ADDENDUM NO. 4

Marianas High School Gym HVAC Project

NMHC IFB 2024-008

Request for Information (RFI)

2 PCU-4 DUCTWORK PLAN, TYP.4
M-1 SCALE: 3/16"=1'-0"

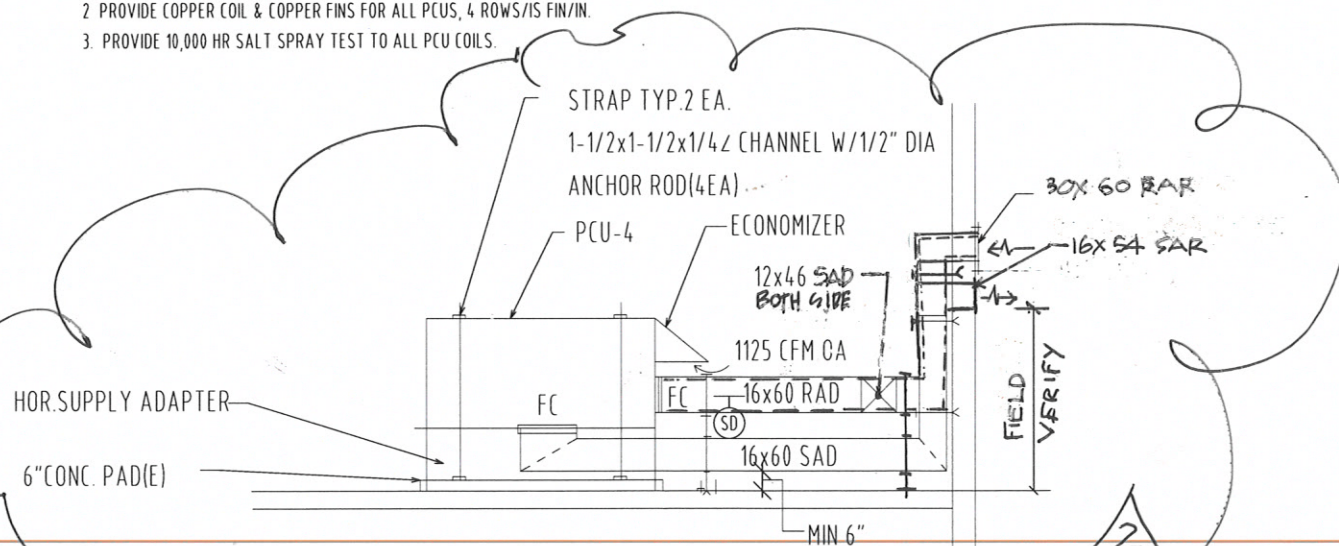
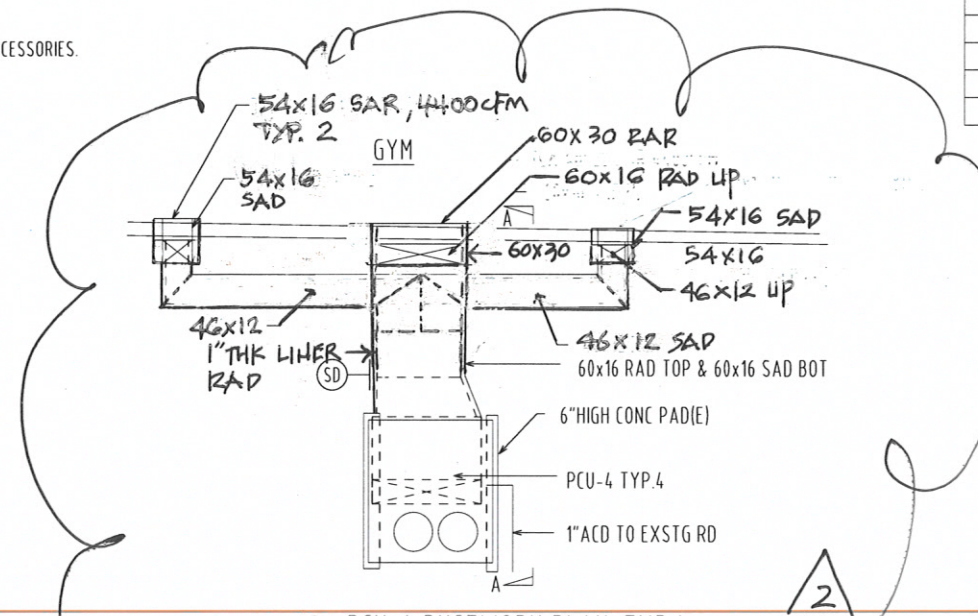
1. PCU-4: Existing design has two (2) supply grilles, 54" x 16" each, and one (1) return grille 60" x 30".

The new design has one (1) supply grille, 96" x 20", and two (2) return grilles, 64" x 12" each, and the supply and return positions are switched.

The new supply opening of 96" x 20" will require cutting into the column. The new return openings of 2- 64" x 12" will require cutting into both the column and tension cables. **Please see attached pictures.**

Also, the new supply position is higher than the return positions. As such, the air circulation will take much longer time. Additionally, the new return positions are lower than supply, and too close. This will divert an amount of cool air into the return before it reaches the lower portion of the building.

RECOMMENDATION: Can we retain the existing supply and return positions?
Which were working properly for many years.

To minimize cost and avoid cutting into existing columns and tension cables, contractor to retain existing supply duct and return duct positions. However, please follow the revised supply and return duct layout as shown in attached Addendum No. 4 Drawings for the revised Sheets M-1 and M-5.

REVISION	REVISED SAD/RAD & SAR & RAR	RD	8/5/24
PROJECT OWNER: COMMONWEALTH OF THE NORTHERN MARIANA ISLANDS		APPROVED DATE	
PROJECT TITLE: PUBLIC SCHOOL SYSTEM MARIANAS HIGH SCHOOL GYM HVAC PROJECT		DATE	
LOCATION: SAIPAN, CNMI		DATE
